Illinois Department of Transportation

SUBJECT: University of Illinois - Willard Airport
Savoy, Illinois
Champaign County
Illinois Project Number: CMI-4606
Contract No. UN058
Item No. 02A, January 17, 2020 Letting
Addendum B

NOTICE TO PROSPECTIVE BIDDERS

CONSTRUCT TAXIWAY A5

EL501
SHEET 25 OF 39

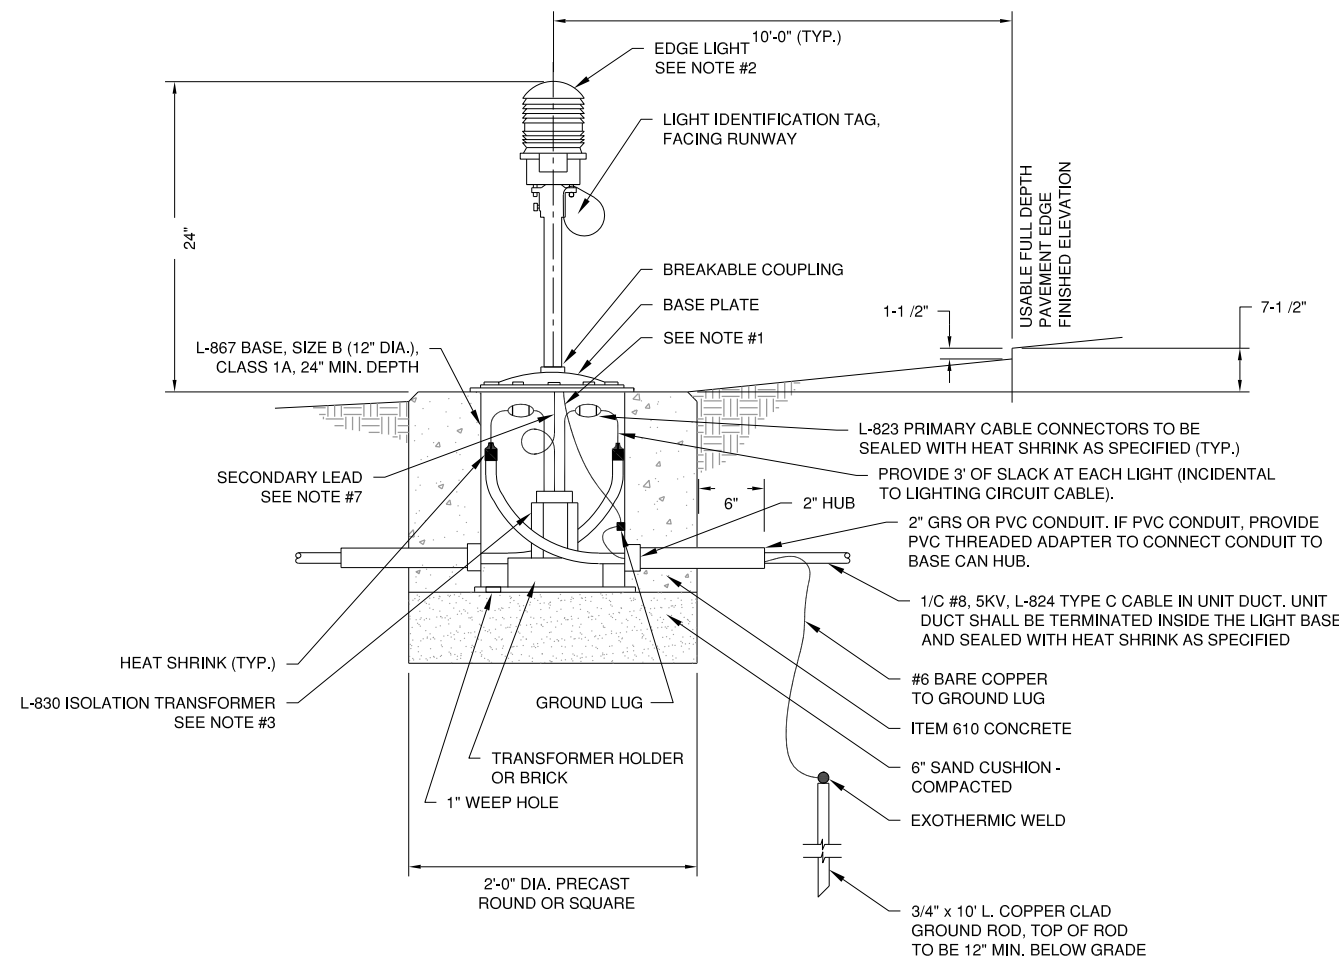
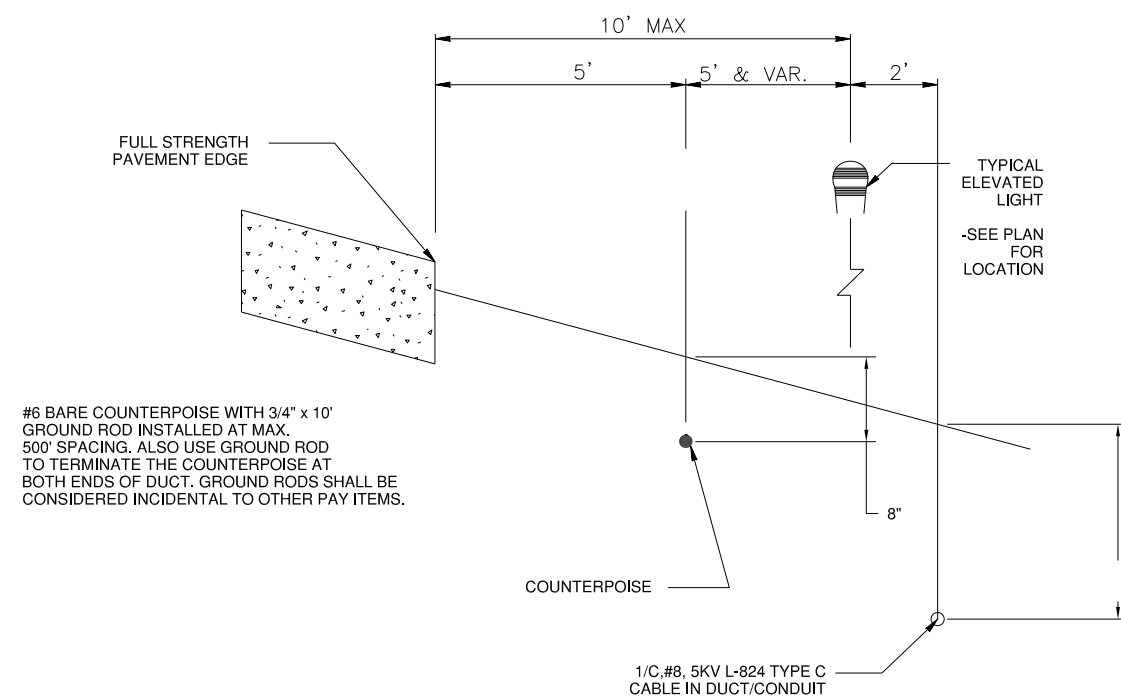
Sheet EL501:

1. Revise Edge Light note 2 to read L-861, as indicated on the plans and specifications. All new lights shall be LED with arctic kits.
2. Revise Edge Light note 3 to read L-830 isolation transformers for LED edge lights with heaters shall be L-830-1.

- LIGHT FIXTURES SHALL BE L-861, AS INDICATED ON THE PLANS AND SPECIFICATIONS, ALL NEW LIGHTS SHALL BE LED WITH ARCTIC KITS.
- L-830 ISOLATION TRANSFORMERS FOR LED EDGE LIGHTS WITH HEATERS SHALL BE L-830-1 30/45 WATT. AS RECOMMENDED BY LIGHT MANUFACTURER.

EL101
SHEET 23 OF 39

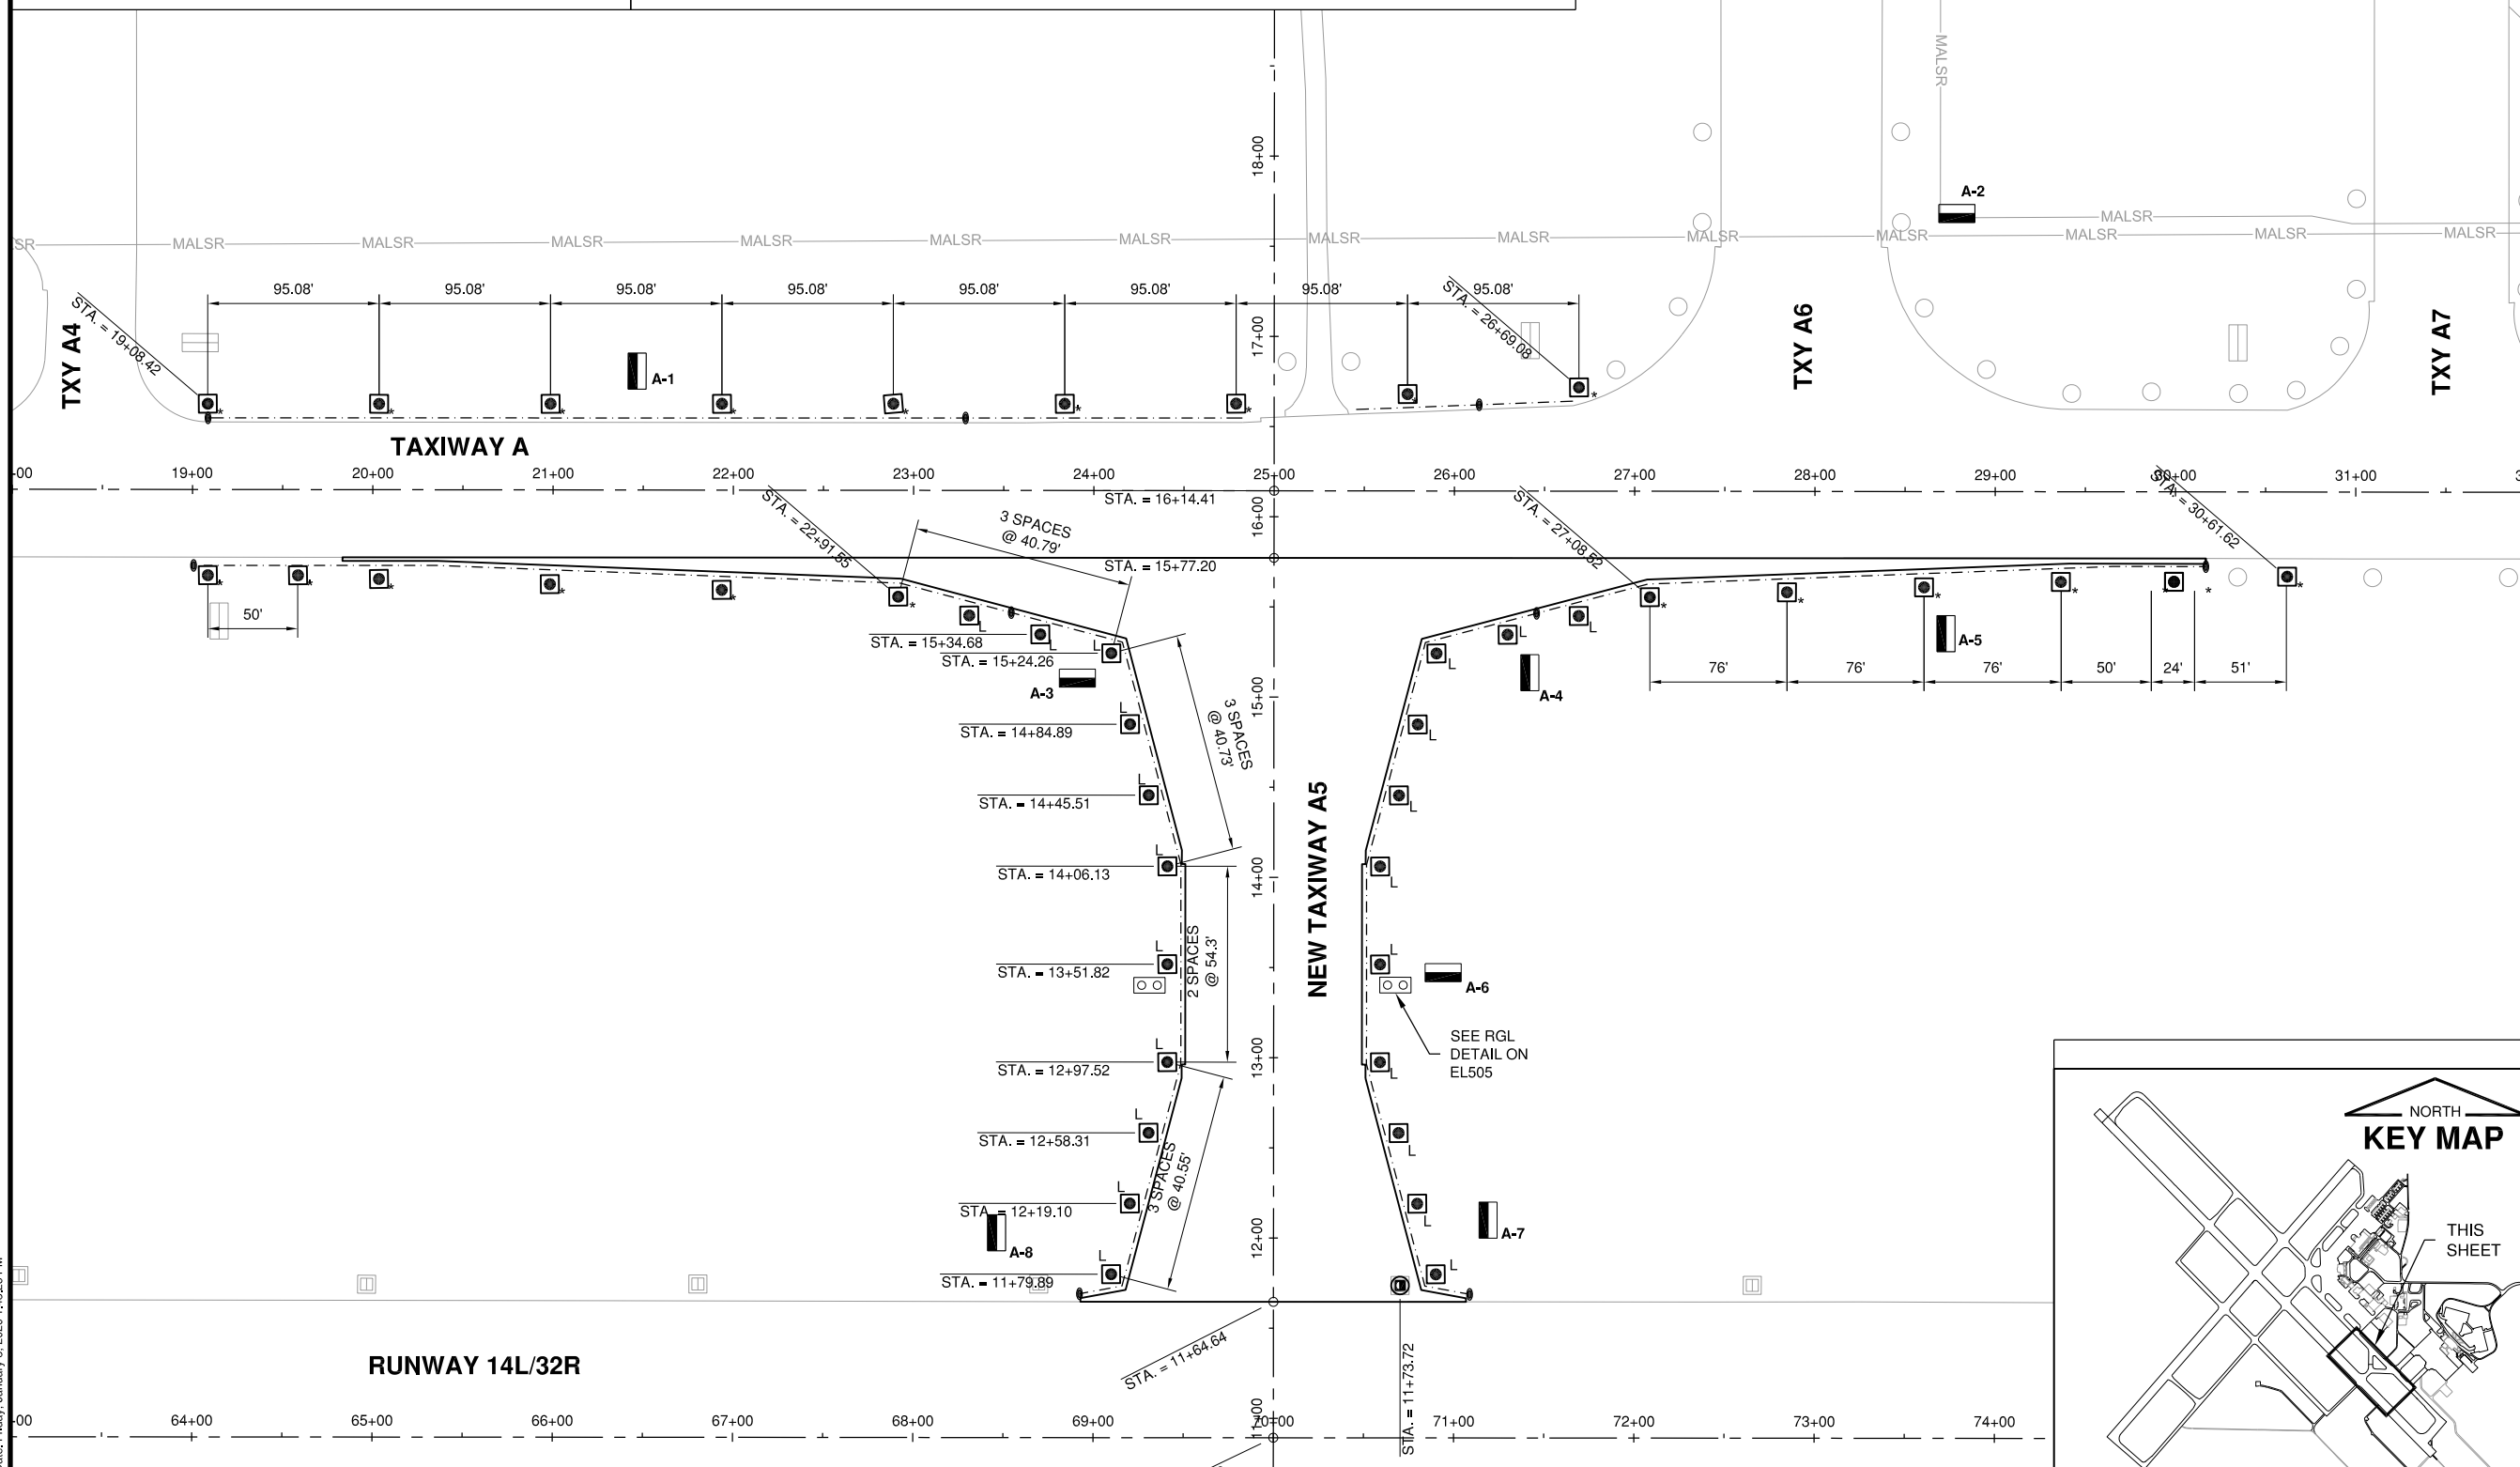
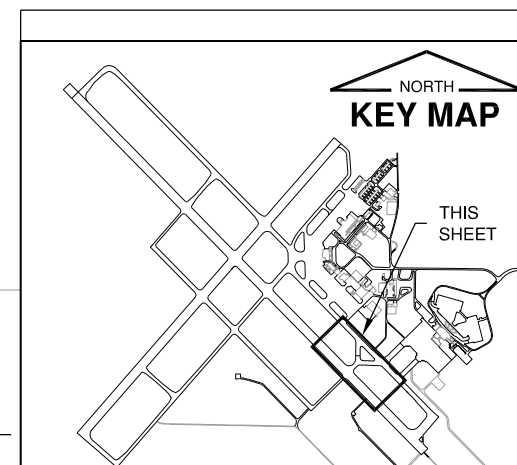
Sheets EL101 & EL504:

3. Revise Lighting and Sign Plan to show Sign A-9 on sheet and add Sign A-9 to the Sign Table.
